CERTIFICATE OF APPROPRIATENESS

Property: 1548 Cortlandt Street, Tract 24A, Block 138, Houston Heights Subdivision. The property includes a historic 988 square foot, one-story wood frame single-family residence and a detached garage situated on a 5,000 square foot (50' x 100") corner lot.

Proposal: Alteration – Construct a 2,085 square foot two story addition and attached garage at the rear of the residence. An original rear bump-out will be removed and one new window will be installed in the north wall.

FIRST FLOOR PLAN

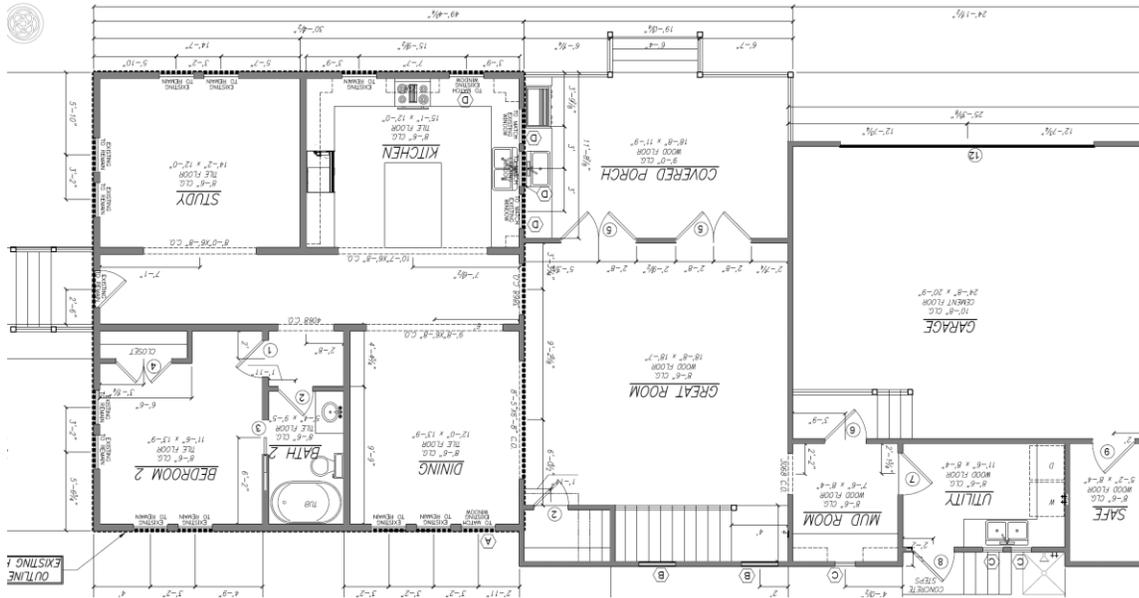
Sanborn maps indicate that this rear bay is original to the house.
